## **DELEGATED DECISIONS BY CABINET MEMBER FOR TRANSPORT MANAGEMENT**

### **WITNEY: WELCH WAY – PROPOSED RAISED PARALLEL CROSSING**

**Report by Director of Environment and Highways**

Annexes	Annex 1: Consultation plan
	Annex 2 Consultation responses

Drawing Date  
Detail Design  
Title  
General Arrangement  
Sheet 1 of 2

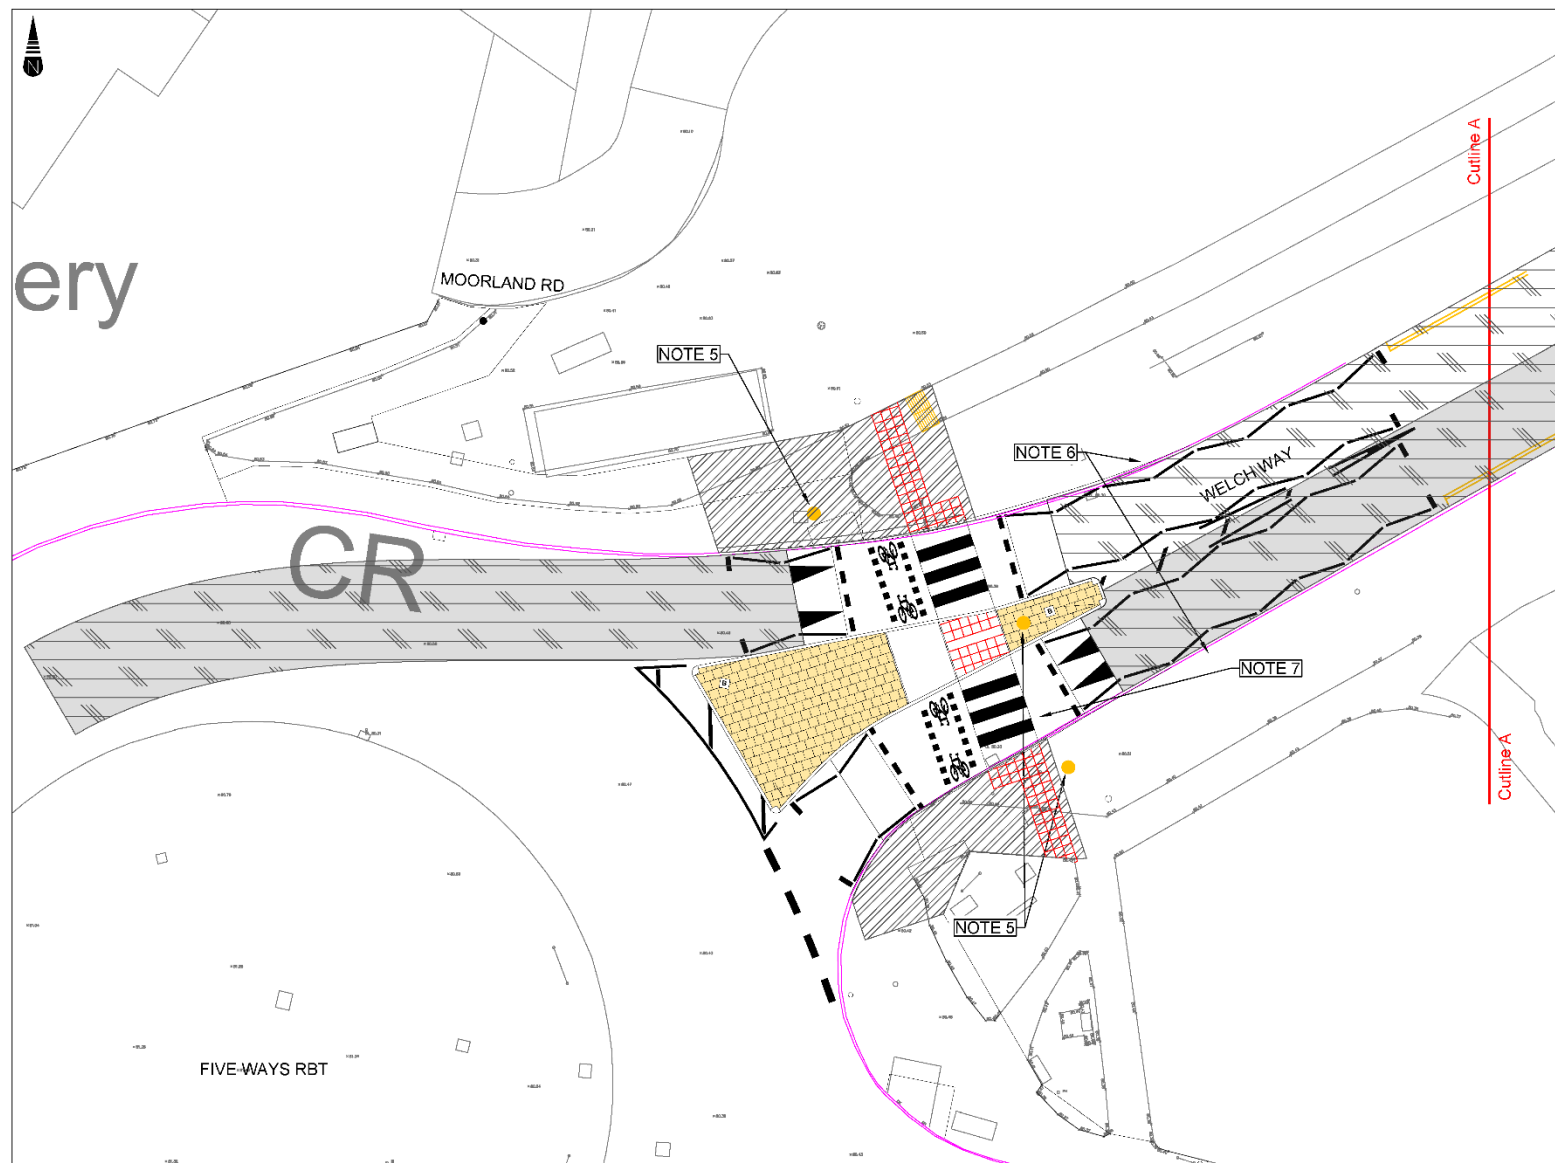
11. Additionally, a further six emails were received directly, with Thames Valley Police raising concerns, stating that the new layout could increase collisions for traffic leaving the gyratory giving precedent to pedestrians and cyclists

13. 'Unlimited Oxfordshire' – a group to help make life in Oxfordshire easier to live for those that have a physical or sensory disability – offered no objection, suggesting that the 'Belisha' beacons should be enhanced with LED or similar lights around the globes, and that the road markings should be refreshed regularly, a further email response raised concerns regarding how the scheme would increase active travel, and what risk assessments & traffic surveys had taken place, whilst a local resident offered their support.

14. Oxfordshire Cycling Network expressed support for the scheme with their viewing it as a significant improvement for both pedestrians and cyclists, and specifically noted their support for the crossing being placed on a road hump. Their response also suggested that the parts of the crossing to be used by cyclists is surfaced in red to highlight their presence, citing an example in Buckinghamshire where they consider this has been used to good effect.

16. One very detailed response from a member of the public expressing an objection noted that the provision for cyclists on the immediately adjacent road network did not comply with the national guidance on cycle provision (Local Transport Note 1/20 Cycle Infrastructure Design- LTN1/20) and also noted that – applying this guidance – the proposal would be categorised as not suitable for all people and will exclude some people and/or have safety concerns. This response also noted that a raised parallel crossing requires authorisation from the Department for Transport.

(o5) Local resident, (Witney, Beech Road)	<b>Object</b> – I forgot to mention that the centre refuge does not appear to meet the minimum length requirement of 3 metres across its full width, meaning there is a risk of cycles overhanging into the carriageway & being struck by traffic.
(o6) Local resident, (Witney, Beech Road)	<b>Object</b> – This is close to a busy roundabout and there is a secondary junction in between.
(o7) Local resident, (Witney, Burwell Drive)	<b>Object</b> – Under the government scheme priority is given to pedestrians and cyclists on roads in this country. Whilst the proposal of a raised crossing for cyclists seems a relatively good idea, and pedestrian crossing, who is going to educate these people to use them in the correct manner. As the ruling stands now anyone approaching a road crossing can step out in front of any vehicle coming towards them and this is where the accidents are proposedly happening, in particular the Welch Way/Corn Street/Ducklington Lane/ Curbridge Road, Tower Hill areas of the roundabout, if you are travelling from Curbridge Road on the roundabout and children/adults/cyclists are on the Welch Way pavement they step out irrespective of a car approaching and the car then has to stop on a roundabout to let them cross to the island in the road, the same applies from Welch Way to Corn Street, they have no idea how to use the crossings.

18. The safety concerns of Thames Valley Police and other respondents on the proximity of the proposed raised parallel crossing to the roundabout are noted; experience at other locations in Oxfordshire with zebra crossings sited similarly close to a roundabout has been acceptable and the proposed placing of the crossing on a road hump should further reduce risks without – as noted by the bus company response referencing the proposed detailed design of the hump ramp gradient and height - resulting in discomfort etc. to vehicle occupants passing over the crossing. Experience of these crossings also suggests there will be no material increase in noise or emissions, a concern raised by a member of the public.

19. As requested in the Oxfordshire Unlimited response, it is intended to provide LED 'halo' beacons to enhance the conspicuity of the crossing beacons.

20. The suggestion by the Oxfordshire Cycling Network for the use of red surfacing on the part of the crossing being used by cyclists will be considered as part of the detailed design.

21. The comments made by a member of the public on the adequacy of the provision for cyclists in the adjacent road network are noted and accepted but are not considered to be a reason for not proceeding with the scheme. Specifically on the concerns on the amenity and safety of users of a parallel crossing at this location, it is agreed the LTN1/20 guidance would – given current traffic flows on Welch Way (approximately 9100 vehicles per day) exceed the 8000 vehicle per day threshold and therefore categorise the proposal as not being suitable for all people and will exclude some people and/or have safety concerns. However, the proposed provision of a raised crossing should – as noted in the Oxfordshire Cycling Network response - significantly reduce risks. It is also confirmed that Department for Transport authorisation for the raised parallel crossing has been sought and obtained.
